# SERVICE INSTRUCTIONS

**No. 0654-391  
ATA Code 34-10**

**SUBJECT:** INSTRUMENT PANEL - MODIFICATION OF THE AIRSPEED INDICATOR MARKINGS

**EFFECTIVITY:** BEECHCRAFT Sport B19, serials MB-617 through MB-655.

Airspeed Indicator Markings

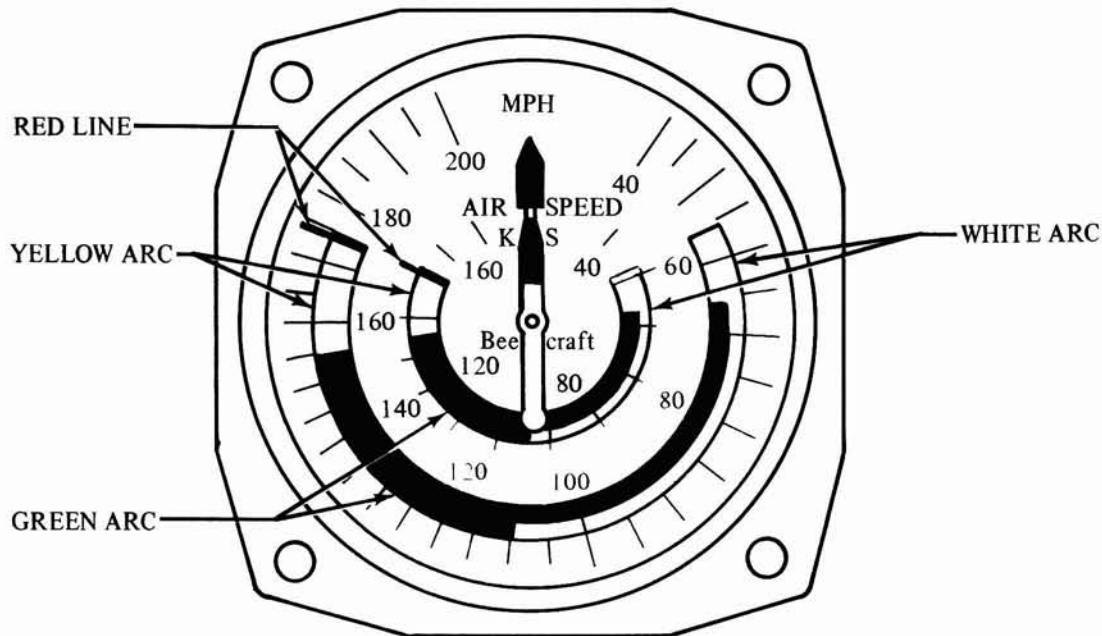
**REASON:** To make airspeed markings compatible with the reduced gross weight.

**DESCRIPTION:** The existing airspeed indicator is to be removed from the aircraft and the markings on the face of the instrument are to be modified by an FAA approved instrument shop.

**ACCOMPLISHMENT INSTRUCTIONS** This modification may be accomplished by removing the airspeed indicator from the aircraft and transporting or sending it to an FAA approved instrument shop for modification of the face markings as shown in the illustration. Upon completion of the modification, reinstall the airspeed indicator in the aircraft and perform a pitot/static system check in accordance with FAA Manual AC43.13-1A.

WHITE ARC		GREEN ARC				YELLOW ARC		RED LINE			
	WORNOW 42-100		WORNOW 42-300				WORNOW 42-200		WORNOW 42-501			
	.156 WIDE		.080 WIDE		.080 WIDE		.156 WIDE		.25 X .045			
	MPH	KNOTS	MPH	KNOTS	MPH	KNOTS	MPH	KNOTS	MPH	KNOTS	MPH	KNOTS
NEW MARKINGS	56-66	49-57	66-110	57-96	66-110	57-96	110-154	96-134	154-175	134-152	175	152
WAS	57-69	49-60	69-110	60-96	69-110	60-96	110-153	96-133	153-175	133-152	175	152
